PLAN COMMISSION AGENDA
January 14, 2019

Eau Claire Plan Commission 1/14/19 Agenda Items

STAFF REPORT

SITE PLAN - 12/02/2018
1750 OX RESIDENCES
1750 N OXFORD AVE. - EAU CLAIRE, WI
A100

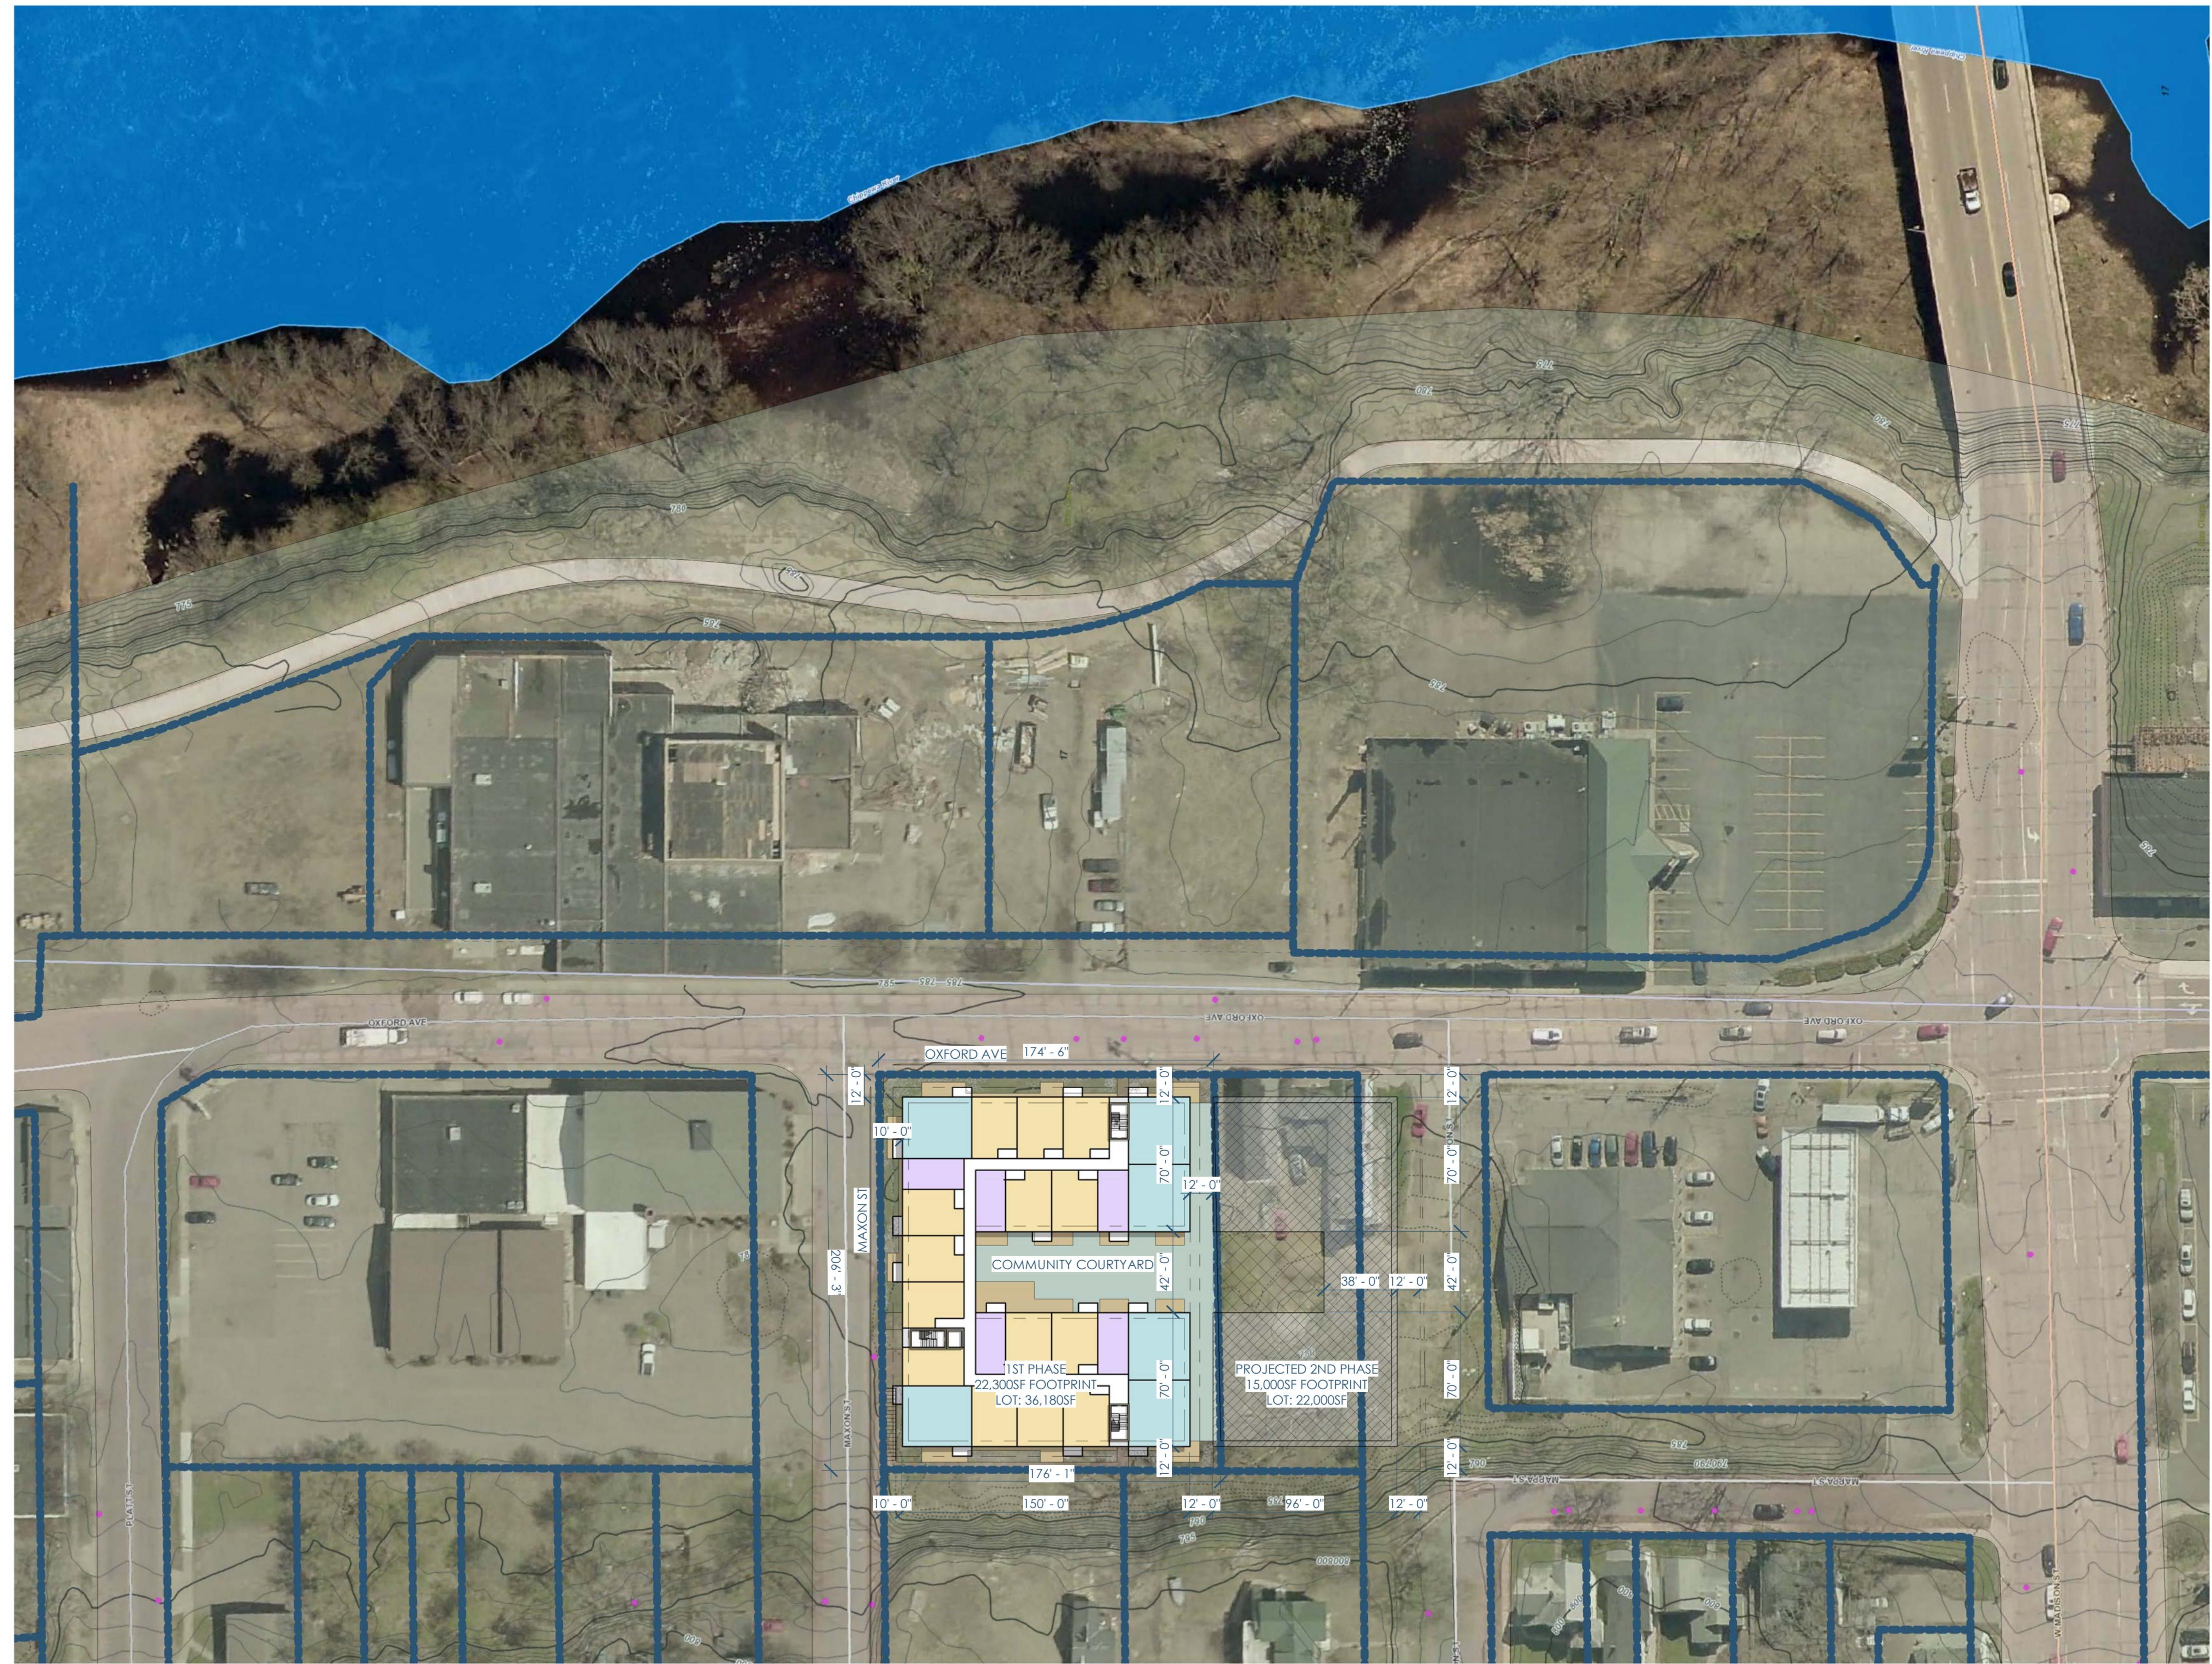
Oxford Avenue is a minor arterial with 6,200 vehicles daily traveling along this corridor. The proposed setbacks are a concern because of the amount of vehicles and the speed at which the vehicles are traveling. In addition, the proposed 7 feet and 5 feet along the street frontage provides little additional room for vehicle error or for landscaping to be added to the site. The rezoning of the property to a planned development provides the opportunity to allow the reductions in setbacks.

The project density is 71 units for first phase and additional 45-50 units for a total property size of approximately 1.19 acres. The proposed underground parking of 66 stalls would require the applicant to add more stalls within the development or reduce the size and density of the proposed project. The parking ordinance is based on one stall per bedroom. This proposed development of 89 bedrooms; with a 10% reduction for transit route and 5% reduction for bicycle parking, a minimum of 76 stalls is required, unless the commission grants a waiver from the required parking ordinance.

Water Quality BMP's will not be required for the proposed site improvements because all areas exposed to vehicular traffic and storage are covered. Water quality BMP's will be required if above ground parking is added to the project.

Land records indicate the log canal/tunnel that transported logs from the vicinity of Dells Dam to Half Moon Lake crosses this property at approximately the vacated alley. The exact location is not known, nor is what if any measures were taken to remove the structure. If the structure is encountered during construction, bulkheads must be installed to seal the ends and prevent sink holes due to soil migration into the tunnel.

1. Provide detailed calculations of the estimated storm water runoff from this plat. These calculations are used to size on-site storm water conveyance systems, size the storm water detention facility, and the discharge piping from the detention facility to the public storm sewer system. Conduct a downstream analysis to determine the capacity of the storm sewer in Oxford Avenue. This requirement may be extended if field surveys indicate further analysis is needed.
2. Enter into a development agreement with the City if it is determined that providing additional runoff conveyance will be provided in lieu of on-site detention.
